City Park Development at the Former Tedcastles Site

Quality Audit

Reference: 267365-ARUP-XX-XX-RP-YT-0015

Quality Audit

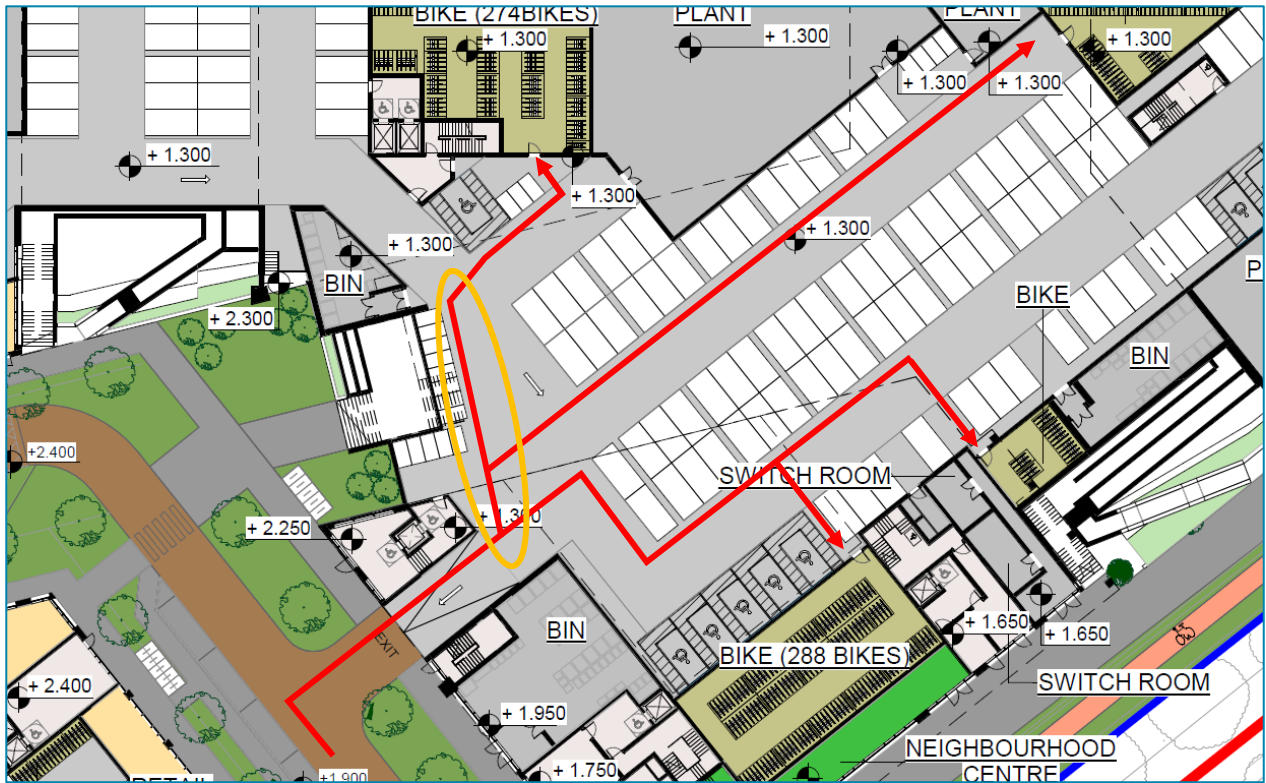
It is proposed that cyclists share the same access ramp to the basement carpark with motorists with no segregation. Cyclists will want to travel at slower speeds while negotiating the ramp which might require sudden braking which increases the risk of collision with a vehicle. Also, cyclists in the up-ramp direction will require more 'wobble' room.

There is also a risk of cyclists slipping in wet weather when entering the car park which could have different surfacing and potentially a tight turning curve at the bottom of the ramp for Block F. It is not clear from the drawing whether rising barriers are proposed on the car park entry but if so, there is a risk of cyclists colliding with them or having to make sudden manoeuvres to avoid them.

Designers Response: Yes | No | It is not possible to increase the width to facilitate dedicated cycle lanes on the ramps. However, ramp lengths are short and gradients are 7% for Block C and E, and Block F facilitates cycle parking access from the street level. Appropriate surfacing and radii will be considered at detailed design stage.

Provide cycle lanes of adequate width along the carpark ramp. Ensure that the vertical gradient of the carpark ramp is no greater than 7% (1 in 14) to keep cycle speeds low. Ensure there is sufficient head room of between 2.2 to 2.4 in height to accommodate cyclists. Ensure the ramp surface is suitable for bicycle wheels and braking, and that there is adequate surfacing and corner radii (if required) beyond the bottom end of the ramp. Also, if there are rising barriers proposed, ensure cycle lanes provide adequate room to manoeuvre around the barriers.

2.3 Problem: Bike Storage Access

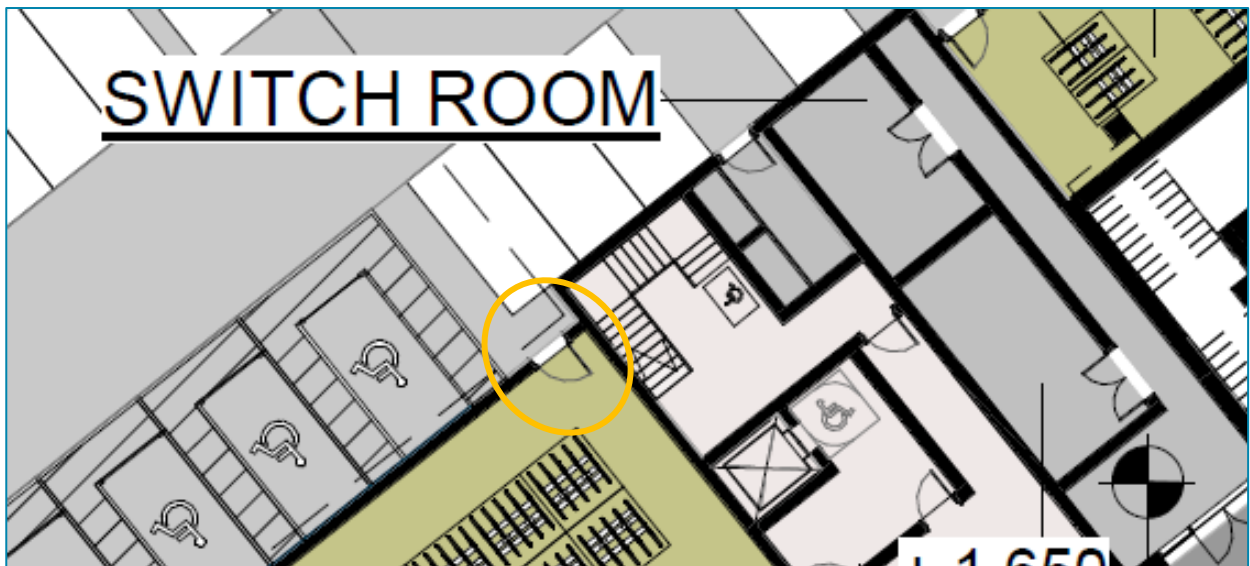
Some of the bike store rooms appear to be difficult to access.

Ensure all of the bike storage areas can be easily and safely accessed by cyclist.

2.4 Problem: Cycling on Footpaths

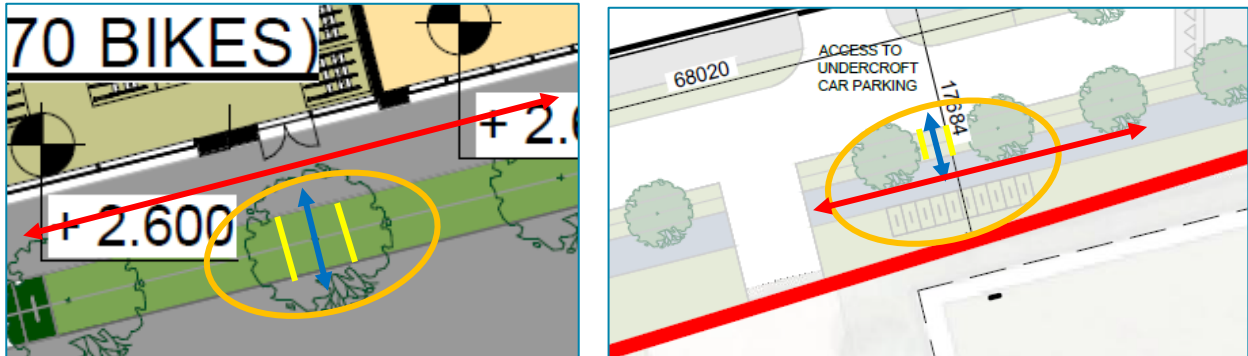
Some of the bike storage areas require cyclists to travel along the footpath in order to access them. Some cyclists may not dismount and walk along the footpath but rather cycle on the footpath and risk colliding with a pedestrian.

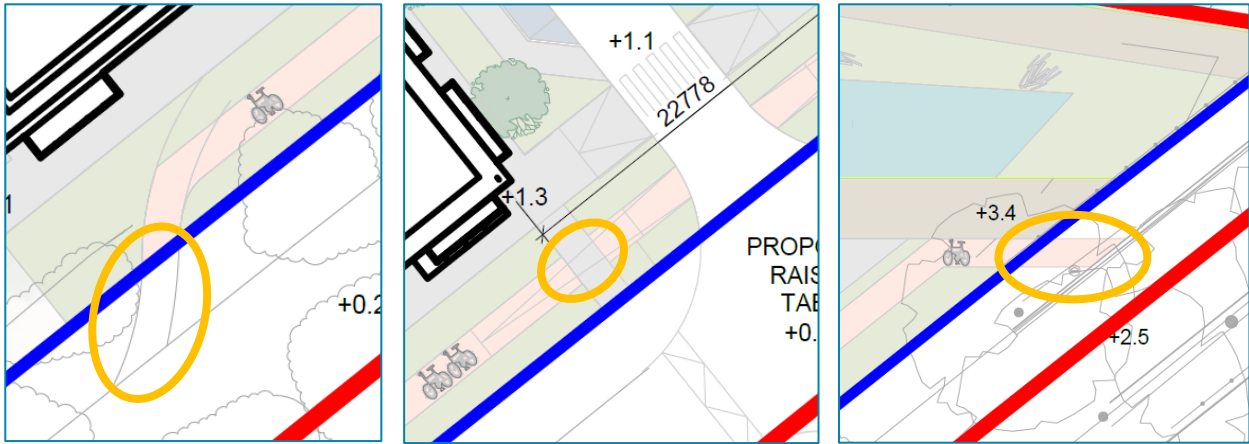
Cycle parking is an integral part of any cycle network and a strategic approach to the provision of bicycle parking facilities will contribute to:

Cycle parking areas with a large number of parking places need careful design, and the parking area layout needs to be borne in mind when selecting the type of rack or stand to be used. Ensure that in general:

- Sufficient bicycle parking spaces are provided;
- Frame-supporting stands are more appropriate for small parking clusters of up to up to 10 or 15 stands;
- The length of a standard bicycle is approximately 2.0m;
- A well-designed parking facility should provide 2.5m between the rows to allow cyclists room to manoeuvre when parking and collecting their bicycles;
- Stands support the bicycle from falling over;
- Stands should protect against theft allowing the cyclist room to position/ lock / unlock the bike;
- Parking stations are well lit and Where possible, protected against the weather.

2.7 Problem: Exposed Water Edge

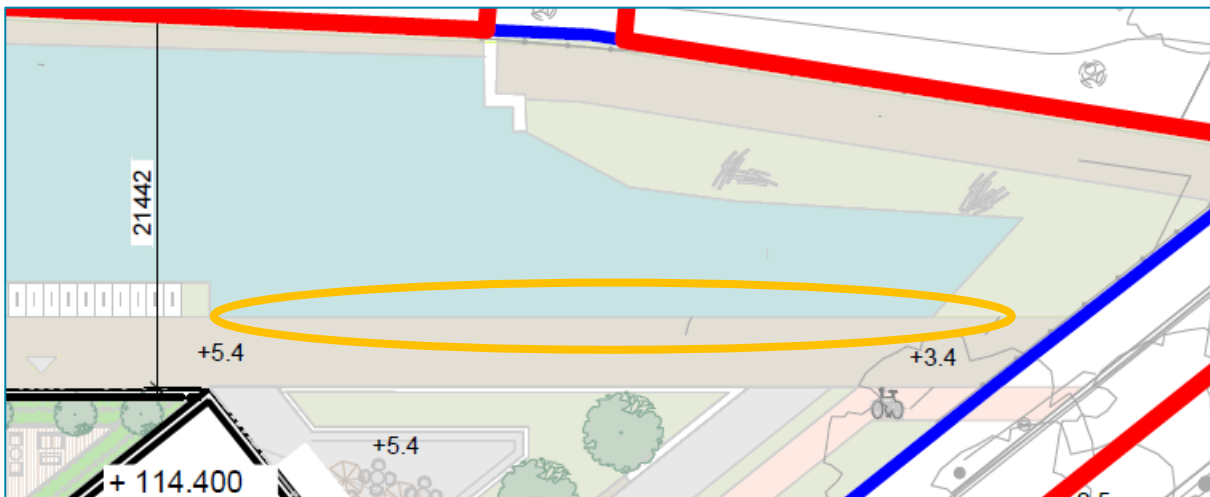
It is not clear from the drawing if it is proposed to install additional protection along the exposed water edge. The change in land use to residential, commercial and more social use will generate new and once off visitor trips who may not be familiar to this danger especially at night. There is a risk that a cyclist especially a young cyclist could fall into water.

Designers Response: Yes | Yes | A railing will be provided and the area will be well lit.

Provide adequate protection along the walkway. Ensure lifebuoys are provided. Ensure that the walkway is well lit at night.

2.8 Comment: Bike Storage Access

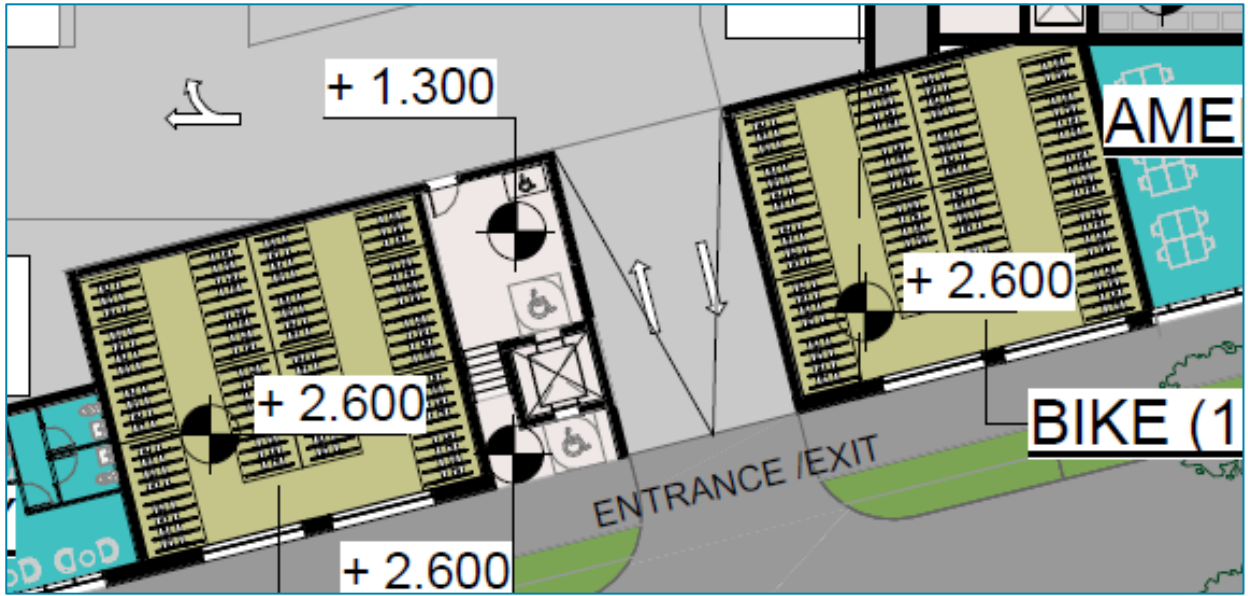
It is not clear from the drawing how cyclists can access some of the bike stores.
